DOE/EA-1574

**Environmental Assessment for U-233 Stabilization, and Building  
3019 Complex Shutdown at the Oak Ridge National Laboratory  
Oak Ridge, Tennessee**

**U. S. Department of Energy  
Oak Ridge Office  
Oak Ridge, Tennessee**

**March 2007**

Figure 1.2, Building 3019 Complex

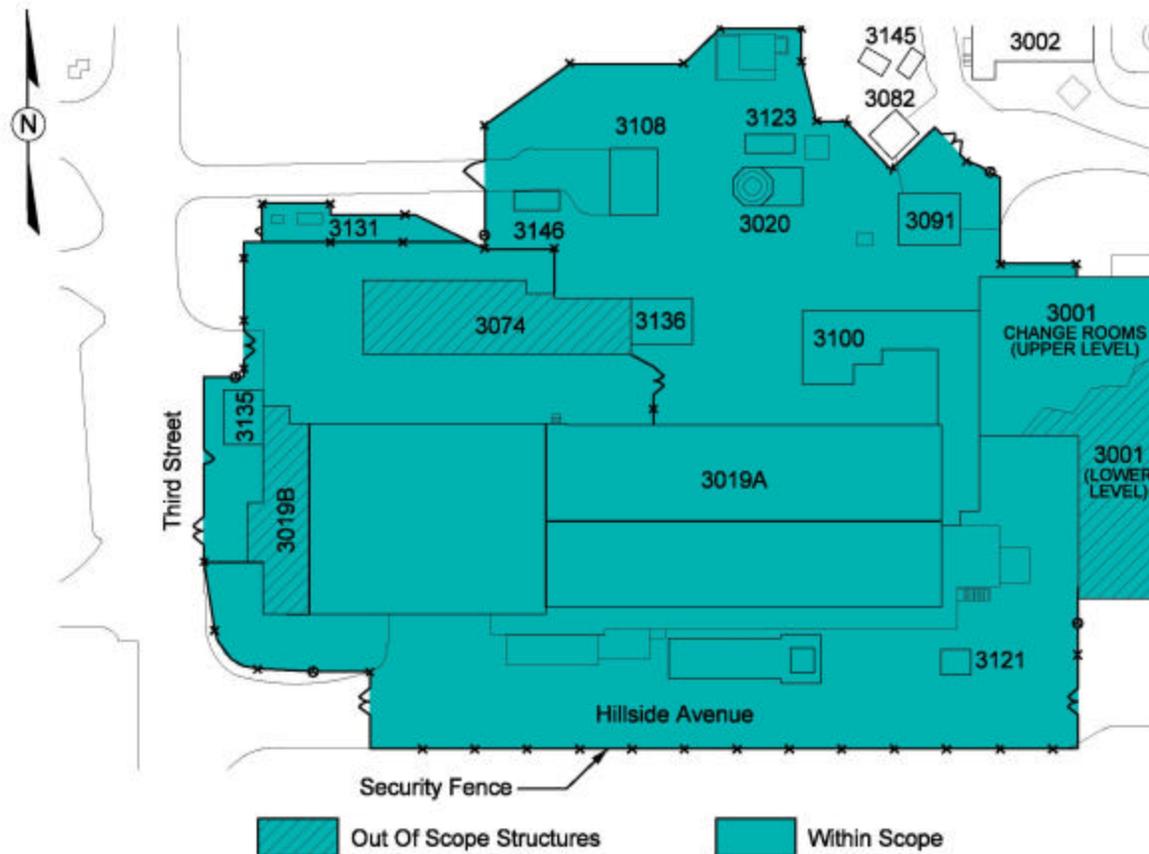
61.	Figure 1.3 is difficult to read in the black and white copy of the EA. Lighter shading should be used.	Figures have been appropriately deleted, added and amended based on final revisions of the EA.

**Figure 2.1, Alpha activity and gamma exposure rate at 1 ft as a function of time calculated for 1 kg  $^{233}\text{U}$  (with 100 ppm  $^{232}\text{U}$ ) as a loose-pour powder (1.5 g/cm<sup>2</sup>) contained in a 3-in. dia. by 6-in. tall can with 20-mil thick steel walls. ORNL/TM-13517**

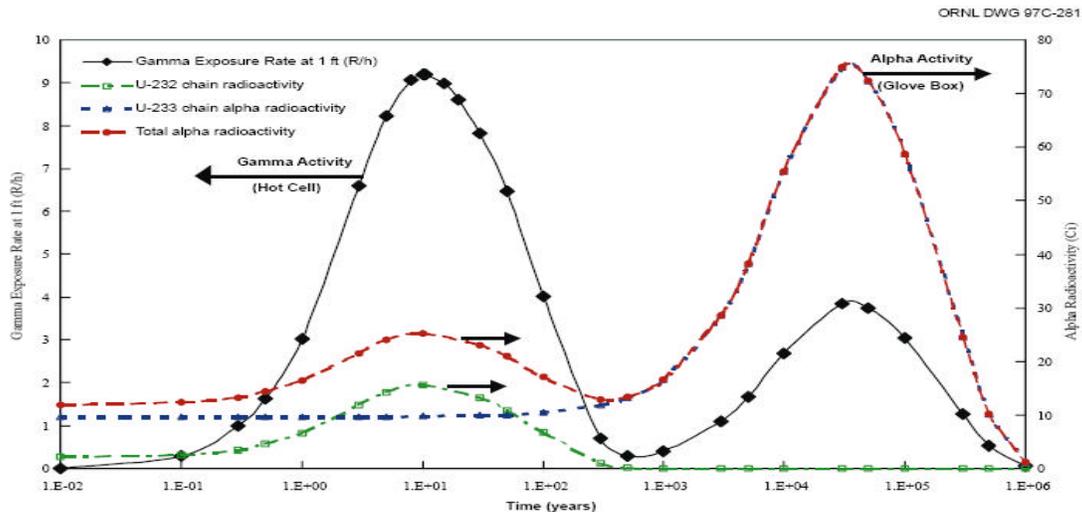
65.	The caption and axes labels on Figure 2.2 are too small to read.	Figure 2.2 and its caption have been excerpted from an external source. Efforts have been made to attempt to enlarge this graphic and correct the caption to read “(with 100 ppm <sup>232</sup> U)”

Figure 2.2 Conceptual <sup>233</sup>U Downblending

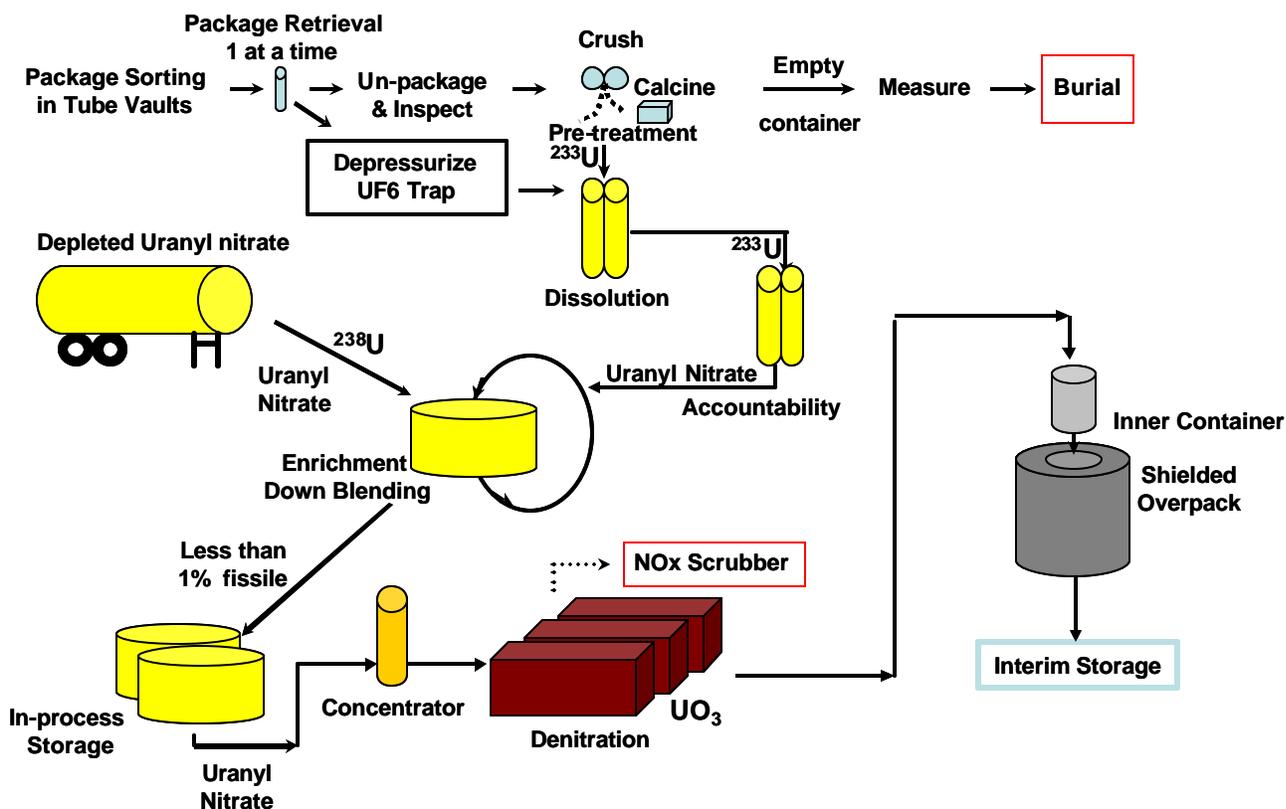
38.	<p><u>Page 11, Figure 2.1 Conceptual <sup>233</sup>U Downblending, Last Sentence of the Paragraph:</u> states that "...the <i>solution (uranyl nitrate) would be transferred from the tanker truck to a tank external to the Building 3019 Complex.</i>" No description of this tank is given in the document. Is it an existing tank? Is it a new tank? What is/will it be made of? Will there be secondary containment? Is this an underground or aboveground tank? This type of descriptive information is relevant to environmental aspects of this document.</p>	<p>The uranyl nitrate will be transferred into an existing Tank P-23. The stainless steel tank is located in a pit surrounded by concrete shielding adjacent to Building 3019.</p> <p>The EA has been modified as follows:</p> <p>Section 2.1.4, 2<sup>nd</sup> paragraph , "to a tank" was clarified to refer to "<i>Tank P-23</i>"</p> <p>Section 2.1.4, the following text was added to the end of the page:</p> <p style="text-align: center;"><i>"Tank P-23 is an existing 10,000 gallon stainless steel tank located adjacent to Building 3019A in a concrete bunker. The bunker is partially below ground and partially above ground and is accessible by removing concrete shield hatches. In the event of a leak, the bunker would serve as secondary containment. The bunker is equipped with a sump pump should the need arise to pump the pit. The tank will be equipped with a high level alarm and the sump shall also be alarmed."</i></p>

39.	<p><u>Page 11, Figure 2.1 Conceptual <sup>233</sup>U Downblending:</u> The figure indicates that the empty <sup>233</sup>U containers will go to burial. Where exactly are these planned for disposition?</p>	<p>Based on past practice and waste characterization data DOE expects that the empty <sup>233</sup>U containers will be disposed of off-site as LLW. The Department will confirm this by characterization once containers are empty and prior to disposal.</p>
